Remarks

Claims 1-21 are in the case. Claims 1-5 stand rejected. The grounds of rejection are traversed and reconsideration is respectfully requested. New claims 6-21 are presented for consideration.

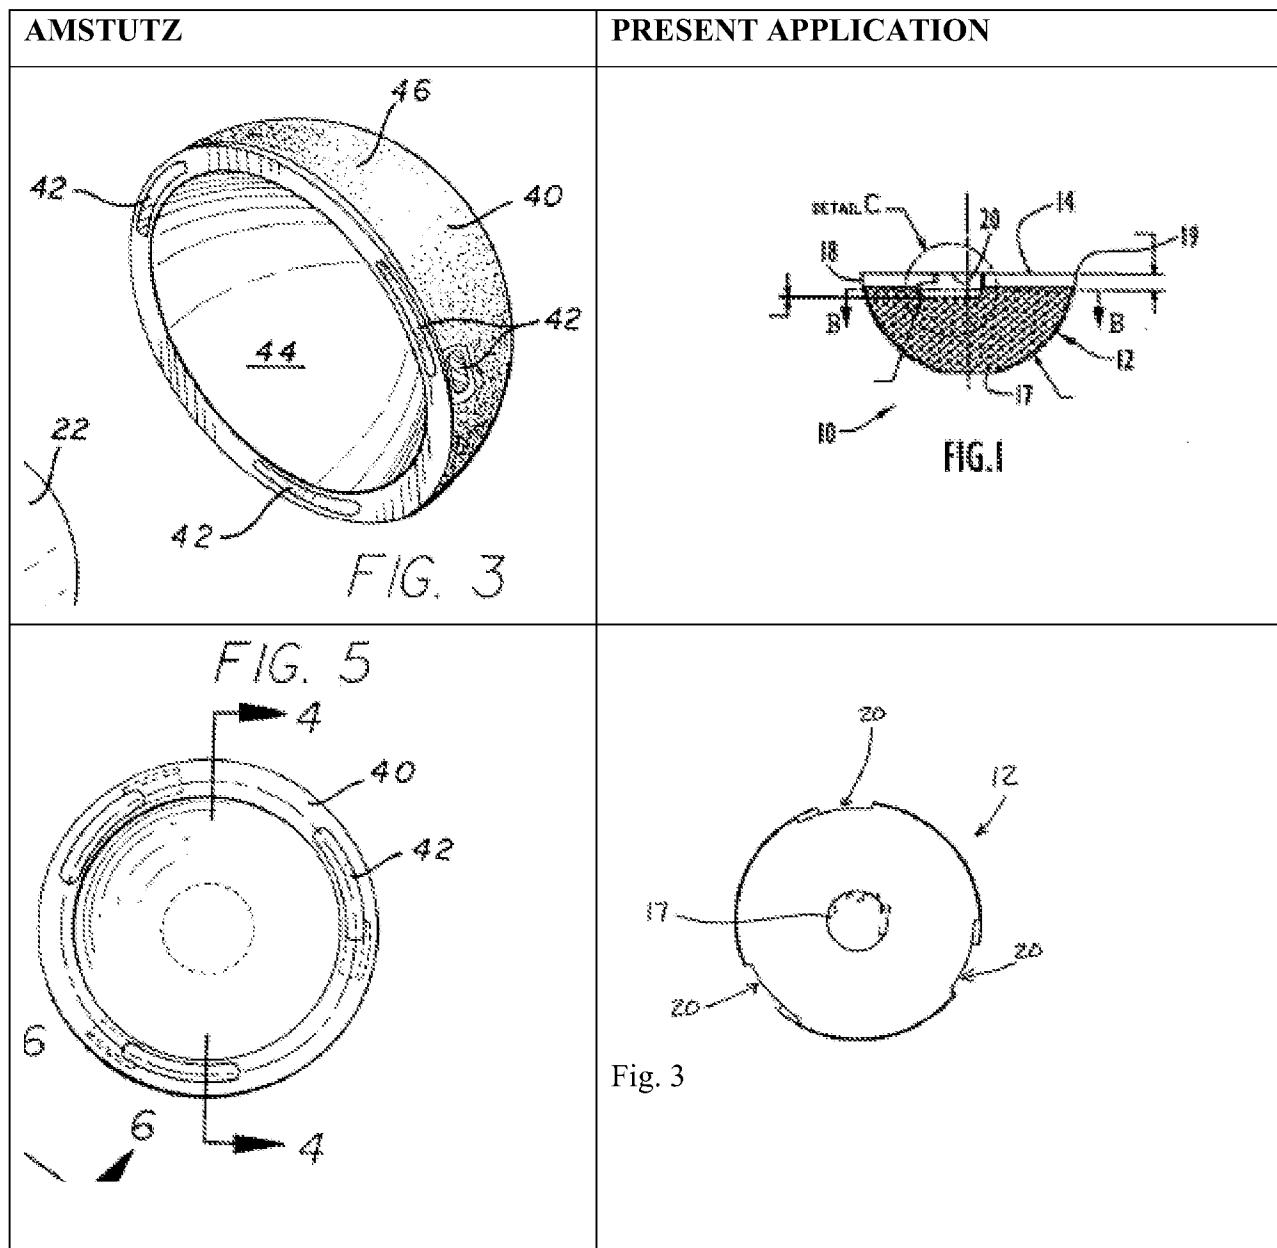
invention to have a substantially thinner wall. The improvement can be visualized by comparing Amstutz Figures 3 and 5 with Figures 1 and 3 of the present application:

In Amstutz Figures 3 and 5, the recess 42 does not have an "open outer periphery extending from said entry portion to said engagement portion." As can be seen in the top view of Amstutz Figure 5, the outer wall is continuous along the outer periphery of the entry portion of the recess 42. As can be seen in the perspective view of Amstutz Figure 3, the continuous outer wall forms an enclosed portion of the recess 42 between the entry portion and the engagement

portion. In contrast, in the bottom view of applicant's Figure 3, there is a break in the outer wall at the location of the recesses 20. In Applicant's Figure 1, it can be further seen that the open area extends from the entry portion to the engagement portion.
